Intel Technical Advisory

TA-1135

Wrong version number printed on the package label for Intel® 2/4U Premium Rail AXXFULLRAIL, Intel® 2/4U Premium Rail AXXSHRTRAIL and Intel® Cable Management Arm AXXCMA2

Figure 1. Example of incorrect Version and Assembly number location in the label

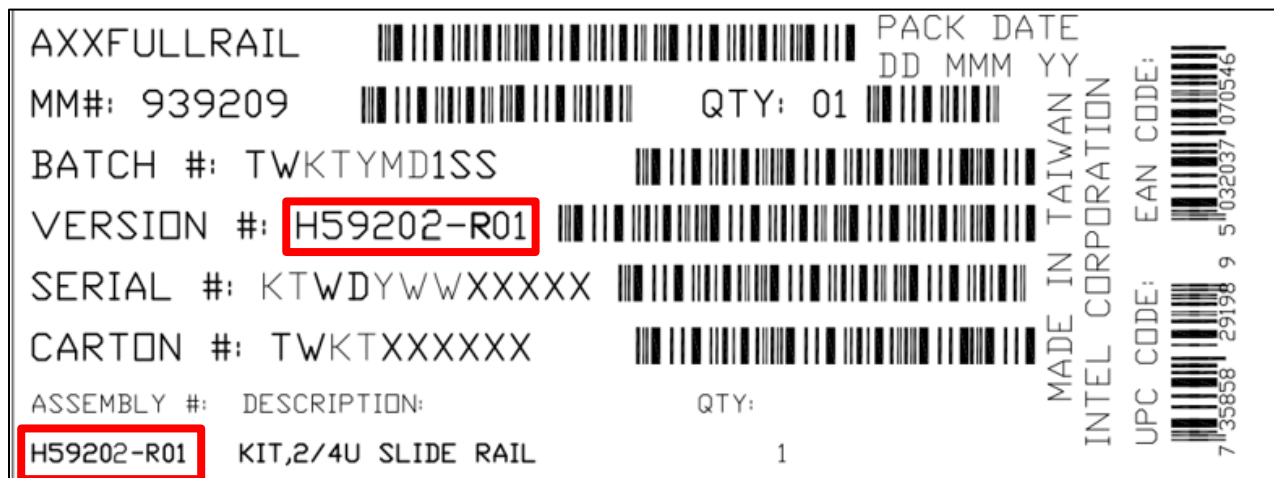
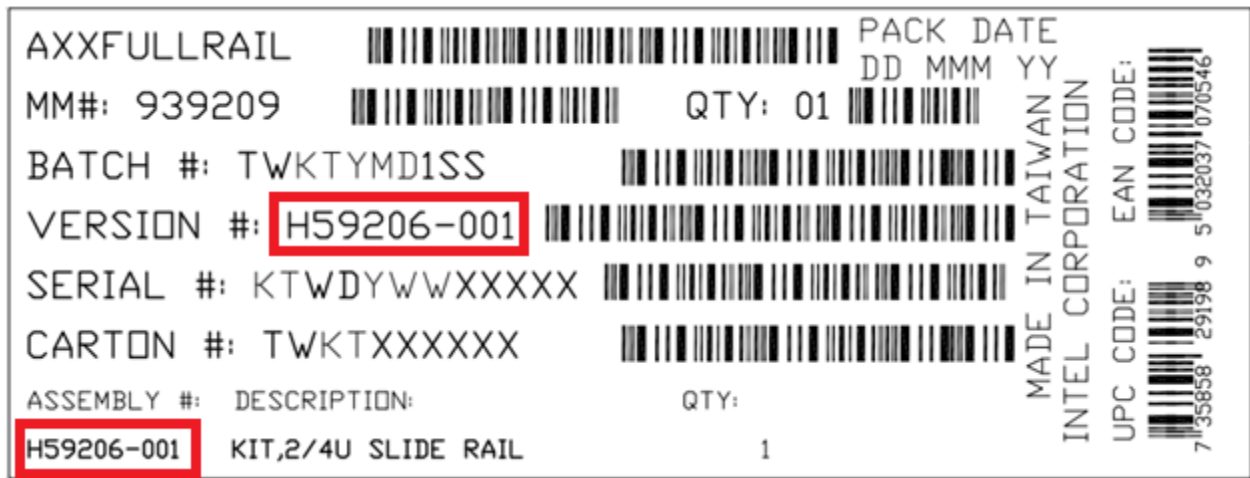
Intel® has discovered a mistake in the assembly and version number printed on the package labels for Intel® 2/4U Premium Rail AXXFULLRAIL, Intel® 2/4U Premium Rail AXXSHRTRAIL and Intel® Cable Management Arm AXXCMA2. The current assembly and version number printed on the labels corresponds to an internal control number instead of the external version used with customers. The table below shows both the wrong version number and the correct one. The location of the affected numbers in the label are shown in the images below.

When printing the labels, the factory used the Intel Part Number of the reference document for the rail kits, instead of the Intel Part Number for the actual rail kits.

Intel® will replace the incorrect labels for all the existing inventory at Intel's warehouse.

Intel® believes this issue does not impact the usage of the products listed on the Affected Products List. Customers can use the table above to identify and track the affected rail kits.
